TITLE : AIR CONDITIONING – COCKPIT AND CABIN TEMPERATURE CONTROL – RELOCATE
COCKPIT TEMPERATURE REGULATION SENSOR.

This page transmits Revision No. 02 of Service Bulletin No. A320-21-1112

SERVICE BULLETIN No. : A320-21-1112

REVISION No. : 02 – Dec 21/00

Figure 13 Sheet 2
Modification to the Equipment in the Cockpit

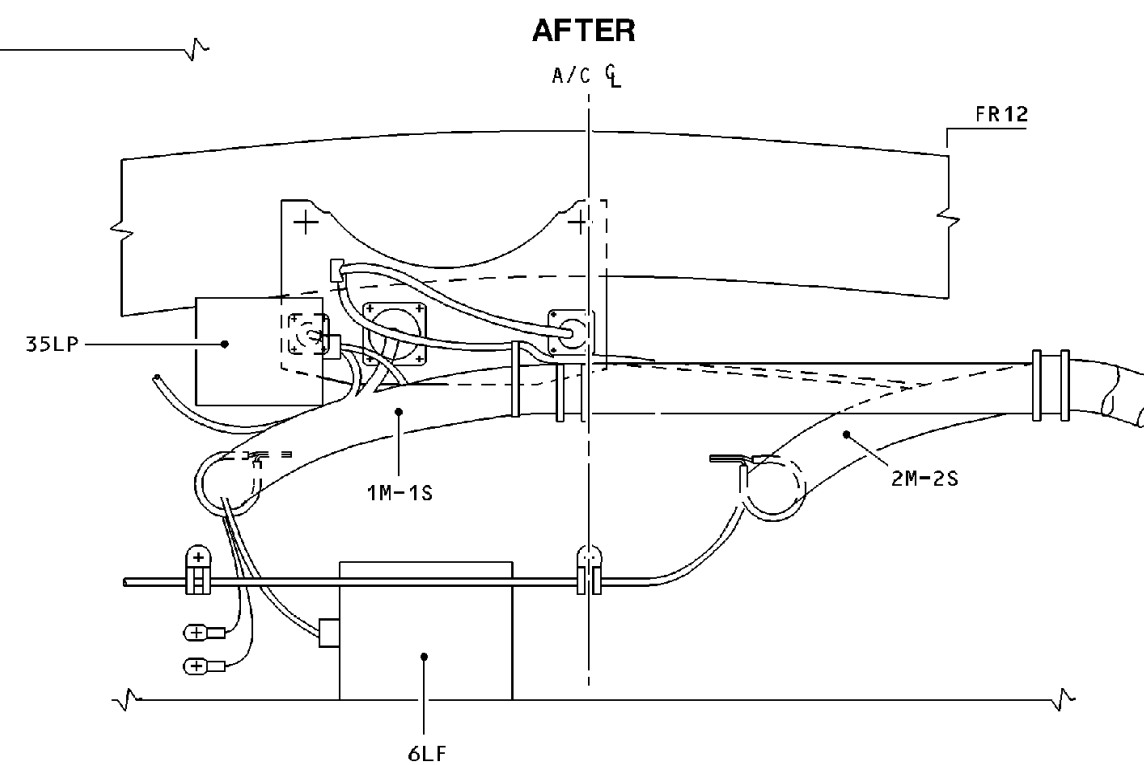
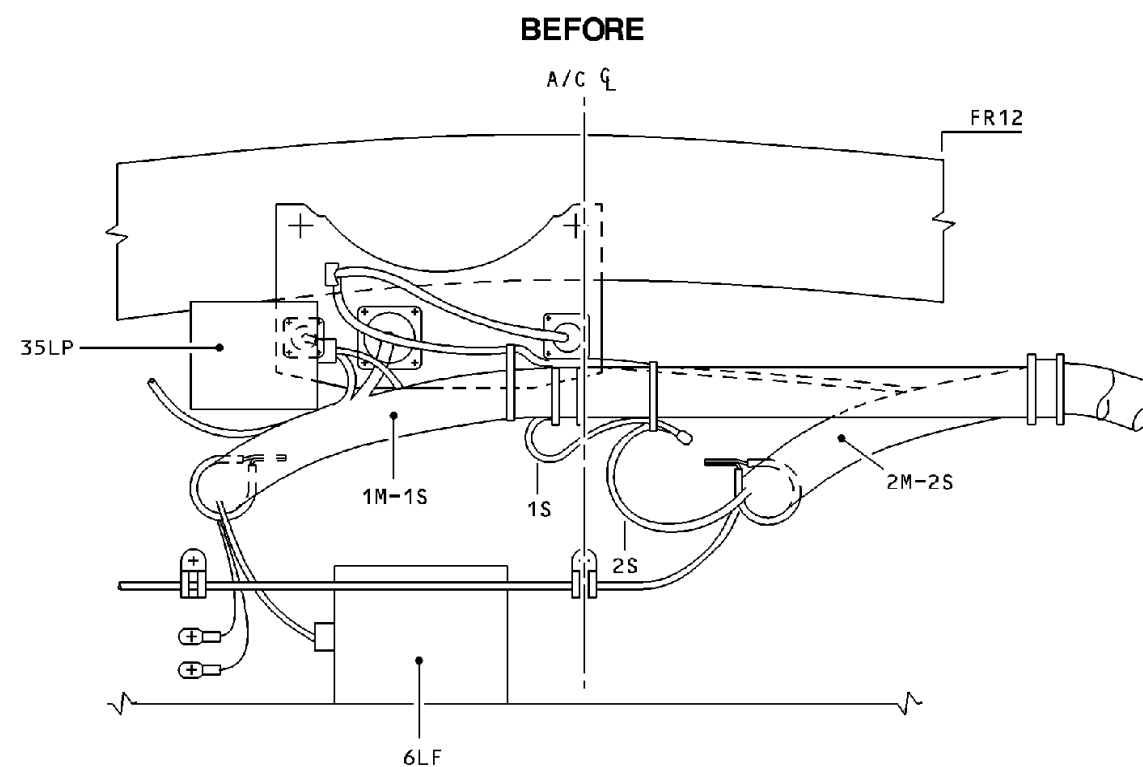
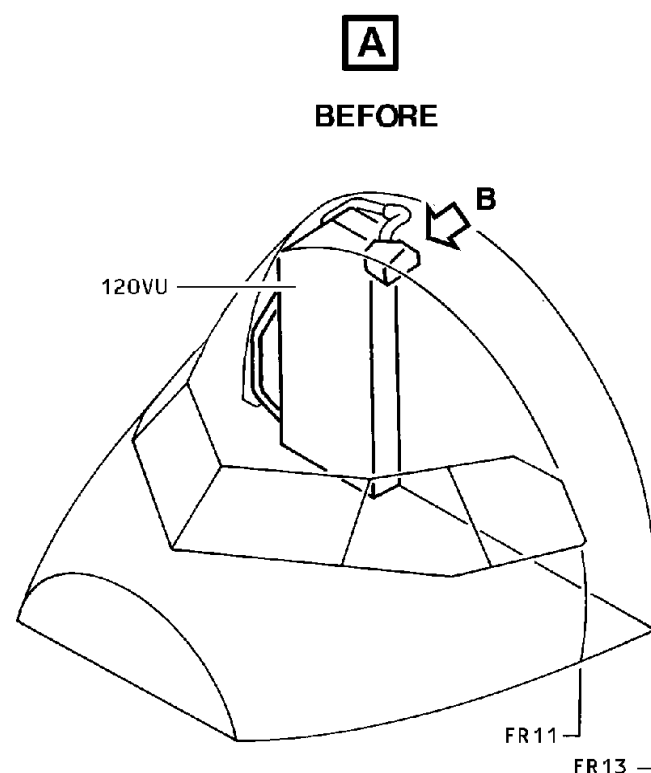
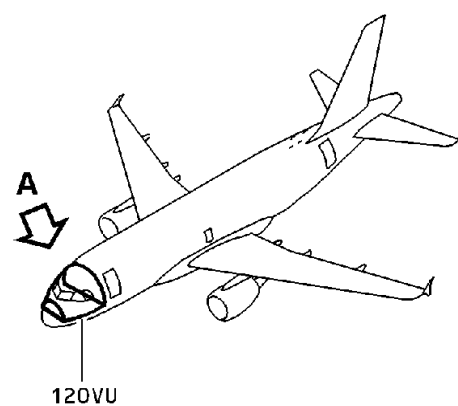
3 Remove the connector 21HK-A
Refer to figure 13
